AEP:NRC:3054-08
10 CFR 2.202

Donald C. Cook Nuclear Plant Unit 1 and Unit 2
REVISED RESPONSE TO REQUEST FOR ADDITIONAL INFORMATION REGARDING RELAXATION OF REACTOR PRESSURE VESSEL HEAD PENETRATION INSPECTION REQUIREMENTS IN NUCLEAR REGULATORY COMMISSION ORDER

REVISED RESPONSE TO REQUEST FOR ADDITIONAL INFORMATION

## Sketch of D.C. Cook Unit 2 Reactor Vessel Head Penetration
(Not to Scale)

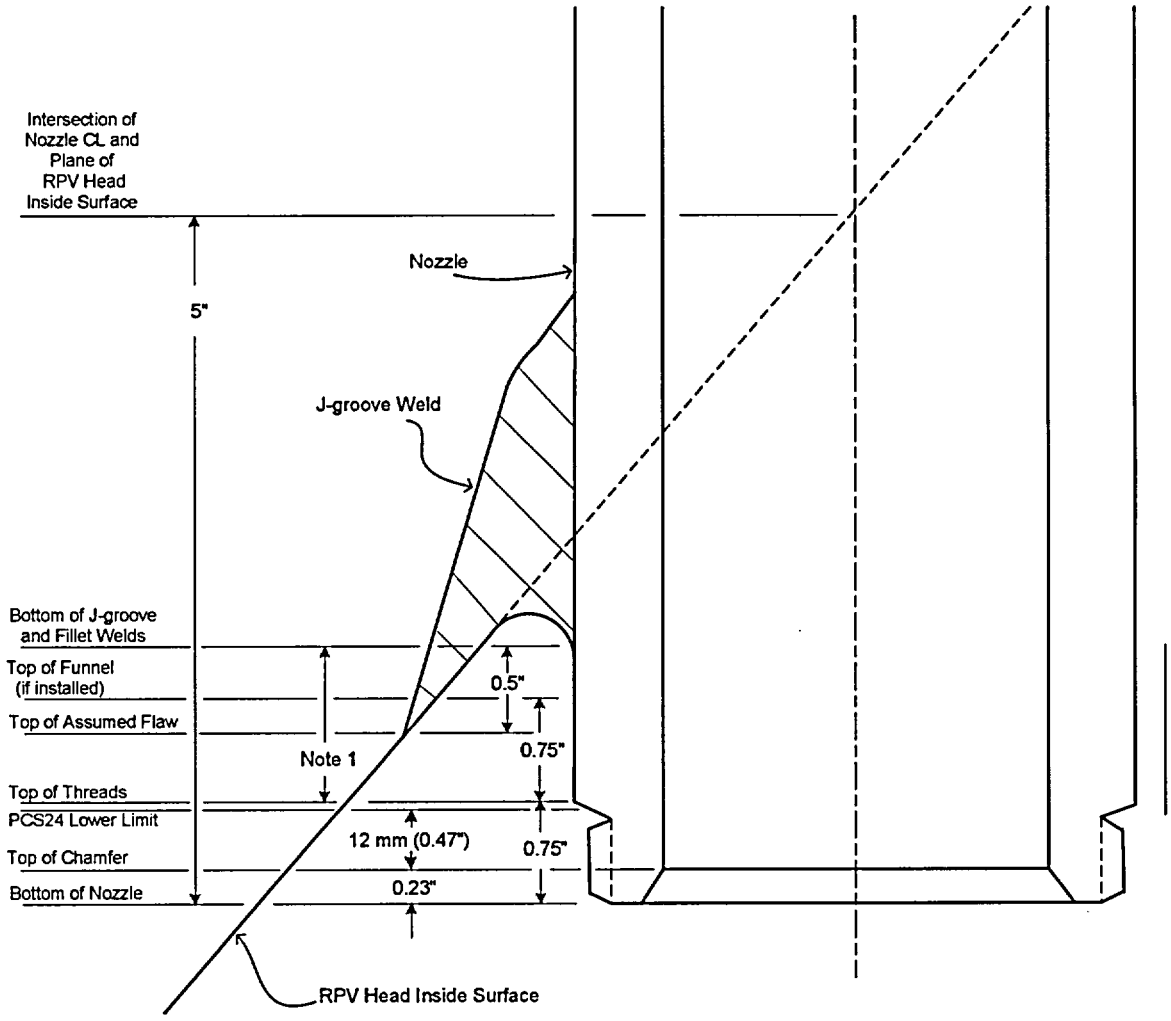
The licensee stated that a small portion of base material will not be scanned on the bottom of the nozzle because the lower transducer and the upper transducer of the probe need to be in contact with the nozzle material. The distance from the bottom of the nozzle upward that cannot be scanned is 12 mm. Please identify the minimum distance from the J-groove weld to the location on the nozzle that cannot be scanned.

The licensee stated that at least five nozzles are threaded approximately 0.75 inches at the bottom of the nozzle. Provide the distance from the bottom of the weld to the threaded area that cannot be examined by UT. Additionally, please provide a more exact count of the nozzles that would be affected.

The licensee is requested to provide a sketch of the nozzle with the necessary dimensioning to clarify the areas covered by the request.

As shown in the sketch provided at the end of this attachment, the distance from the bottom of the nozzle upward that cannot be scanned due to the PCS24 probe transducer arrangement has been calculated to be 12 millimeters (0.47 inches) plus the height of the chamfer (0.23 inches). The minimum distance downward from the J-groove weld to the location on the nozzle that cannot be ultrasonically scanned due to the PCS24 probe transducer arrangement has been calculated to be approximately equal to the minimum inspectable distance resulting from the external threads on the nozzle. As described in the response to NRC Question 3, with one exception, the minimum inspectable distance resulting from the external threads has been determined to be 0.68 inches, based on best estimates by personnel reviewing ultrasonic inspection results. The one exception is discussed in the response to NRC Question 3.

With one exception, the minimum distance from the J-groove weld to the threaded area has been determined to be 0.68 inches based on best estimates by personnel reviewing ultrasonic inspection results. The tolerance on this value is estimated to be plus or minus 10 percent. This minimum distance occurs on the downhill side of one penetration in the third row from the outermost row ("45.8°" in Attachment 2). The "downhill" side of the penetration is the side farthest from the centerline of the RPV head.

A sketch has been provided at the end of this attachment.

Note 1: The minimum distance from the bottom of the J-groove and fillet welds to the top of the threads (except for penetration 73) is 0.68." - This occurs on the downhill side of one penetration. For penetration 73, the minimum distance the from bottom of the J-groove and fillet welds to the top of the threads is 0.36." The OD of Penetration 73 was dye penetrant tested to the bottom of the nozzle and the OD was eddy current tested to the top of the chamfer. The distances from the bottom of the J-groove and fillet welds to the top of the threads are based on best estimates by personnel reviewing ultrasonic inspection results.

GRAPHS OF STRESS VERSUS DISTANCE BELOW J-GROOVE WELD

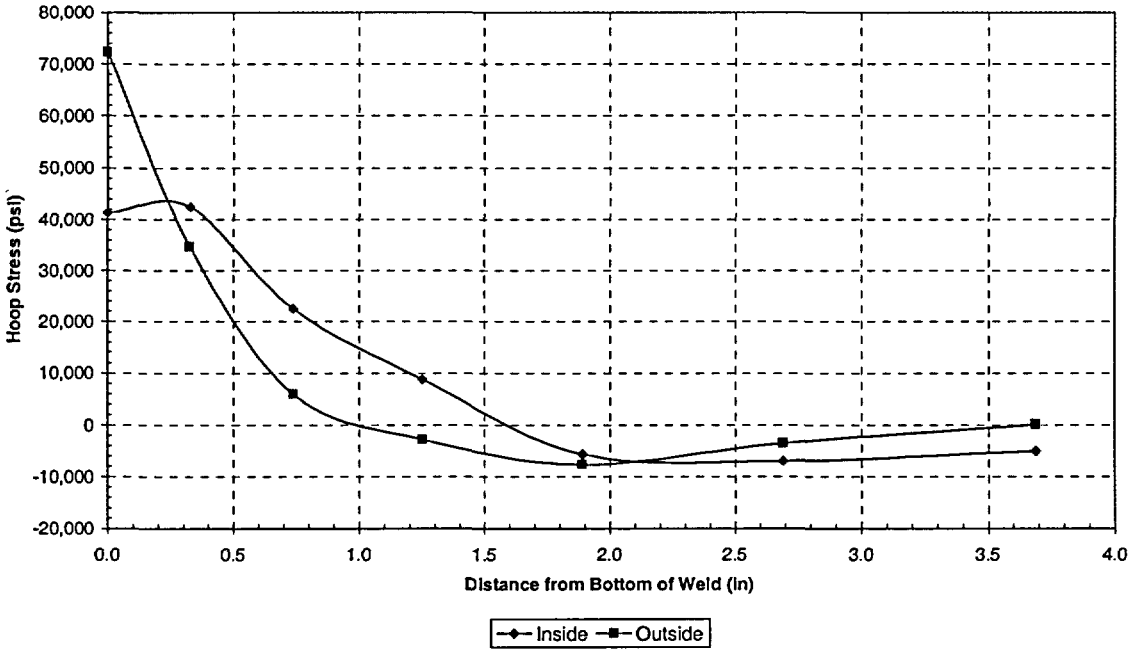
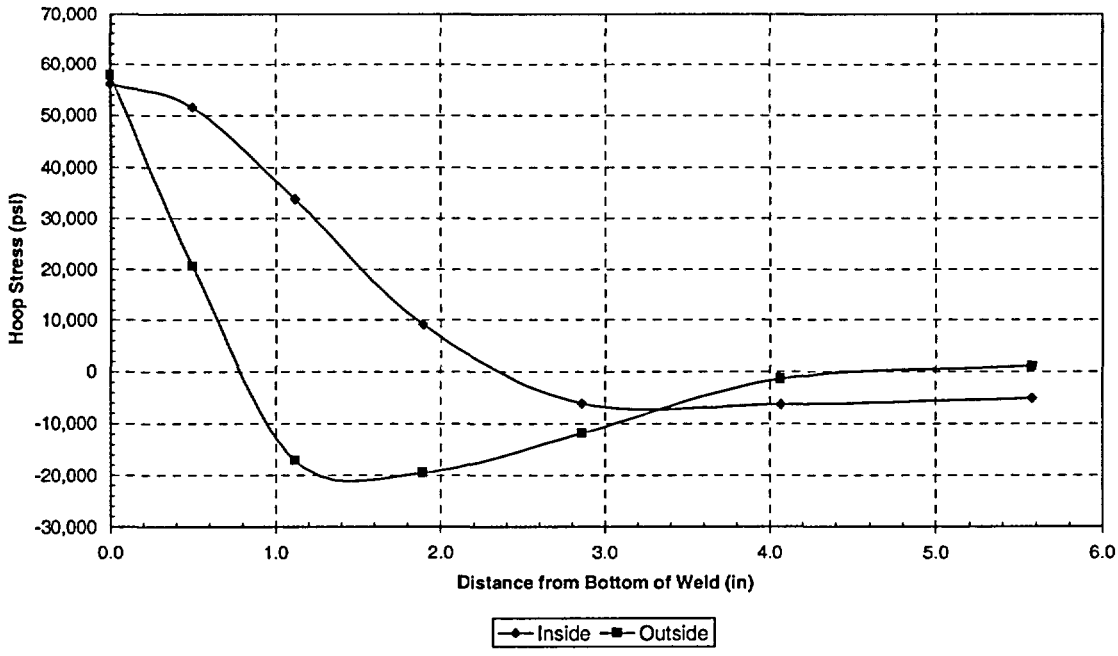
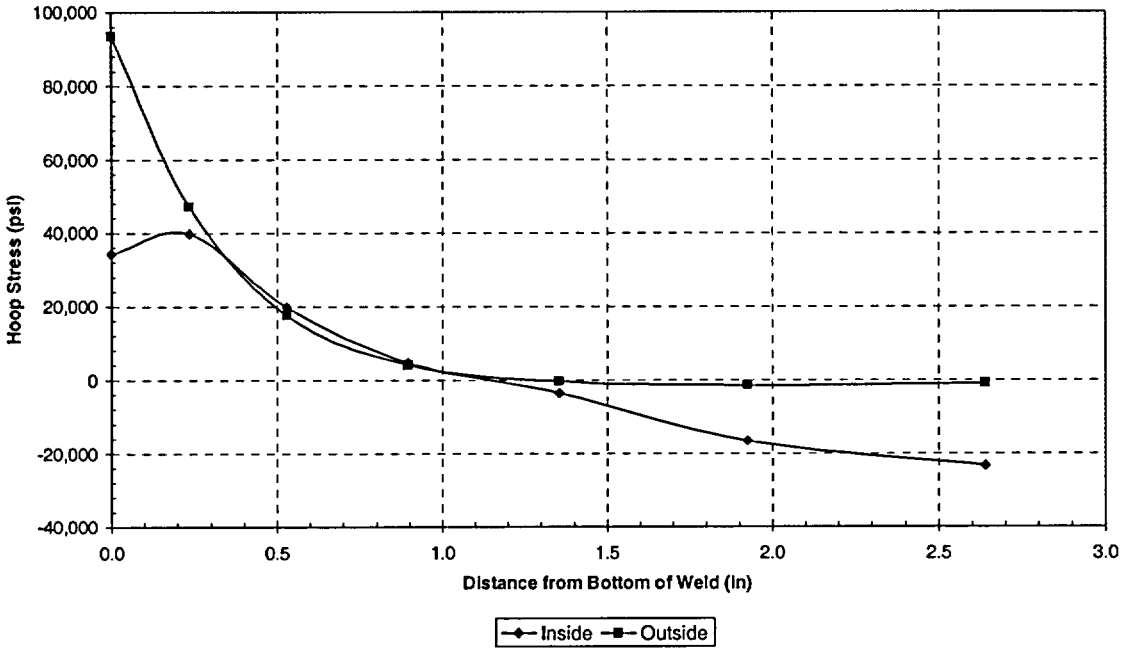
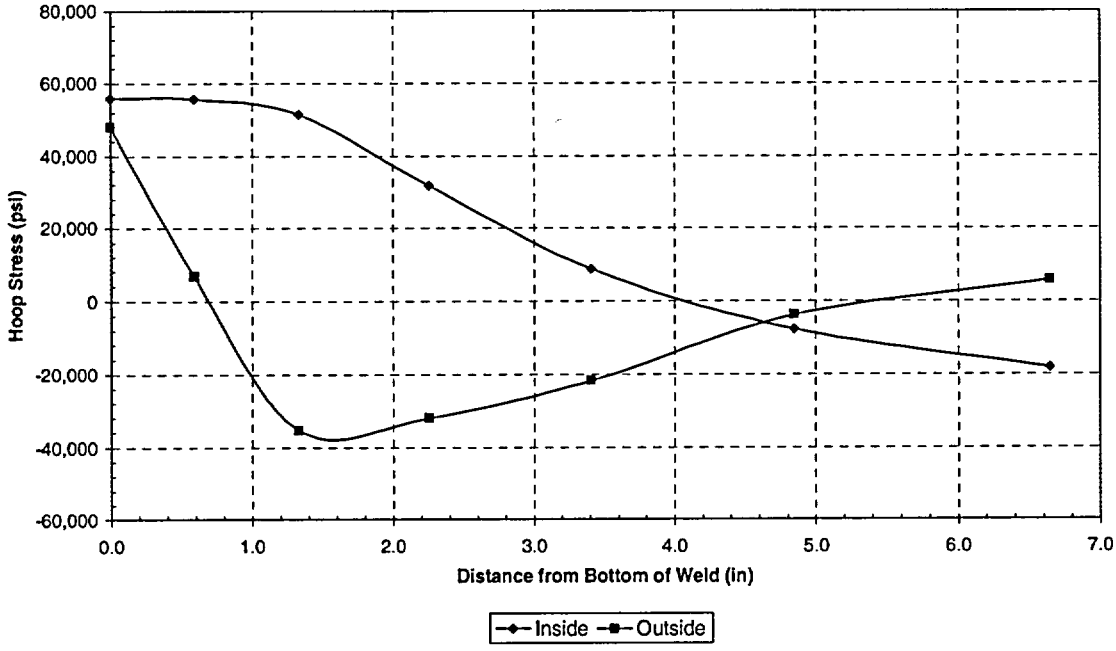
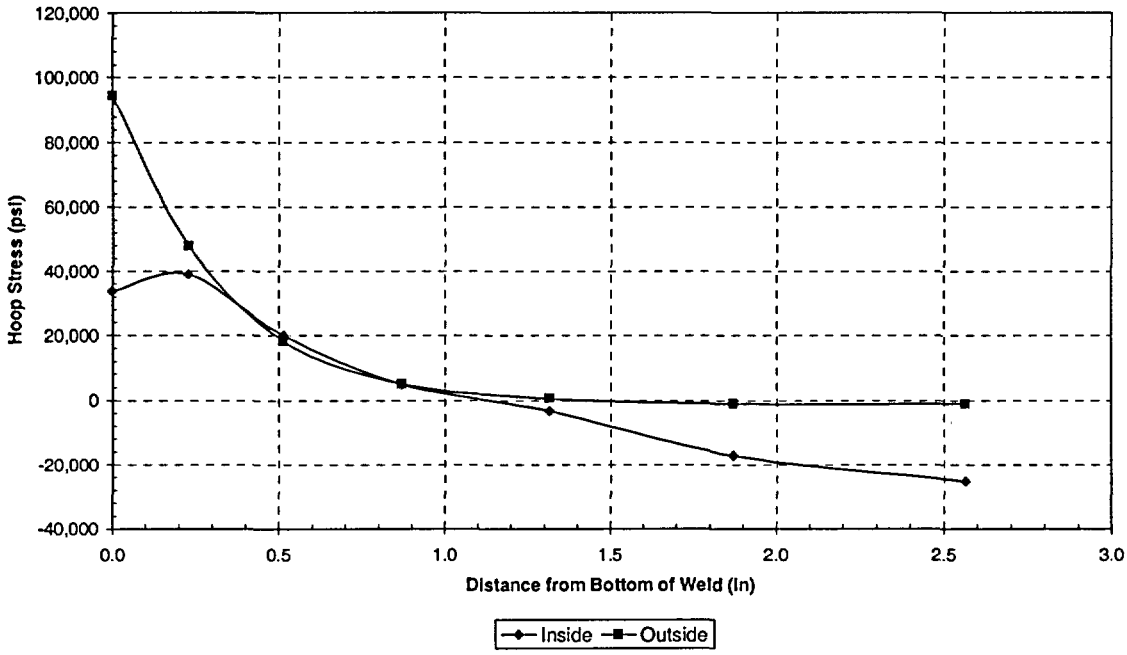
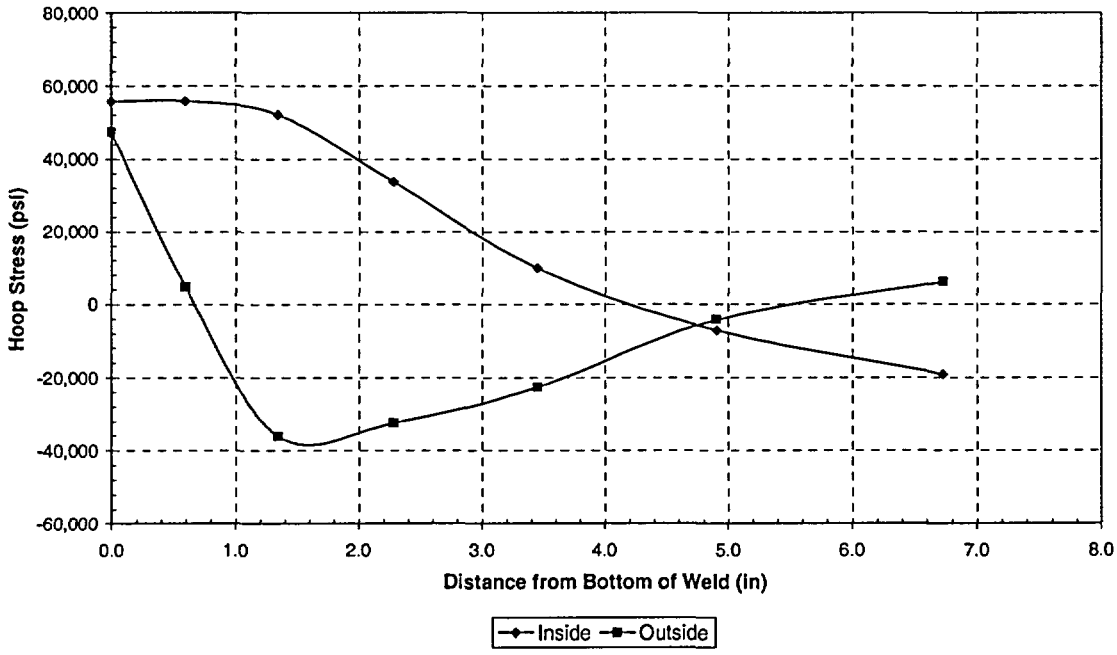
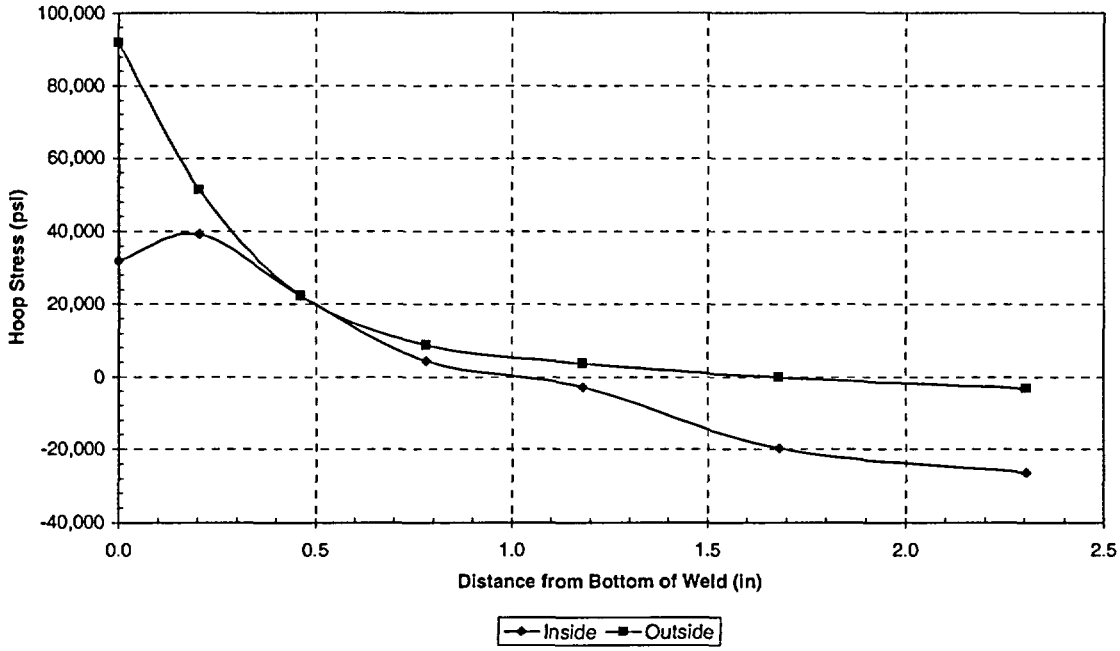
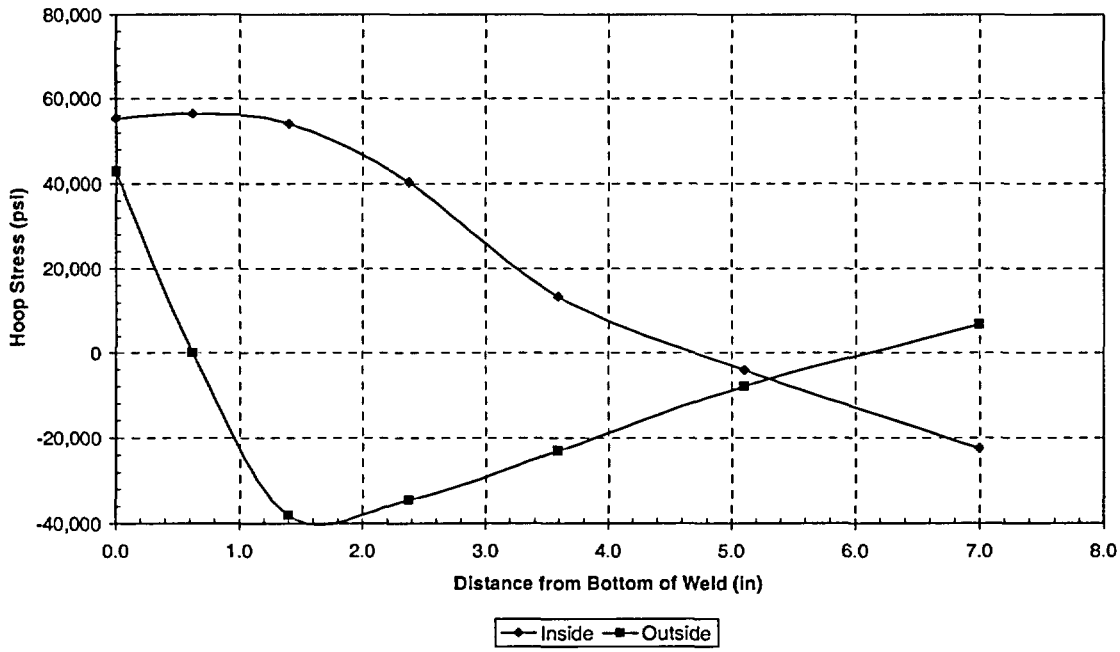
Provide additional technical justification (i.e., operating stress levels, crack growth analysis, etc.) that supports the licensee's statement that the small area that cannot be scanned is insignificant to the phenomena of concern.

The steady state and residual stresses in that area are shown in Attachment 2 to this letter, which provides graphs of hoop stress versus distance below the J-groove weld for various nozzles from the center of the Unit 2 RPV head to the outermost row. As shown in these graphs, the stresses in the area of the nozzle that would not be inspected are low relative to the yield stress of the nozzle material (41,000 to 63,000 pounds per square inch).
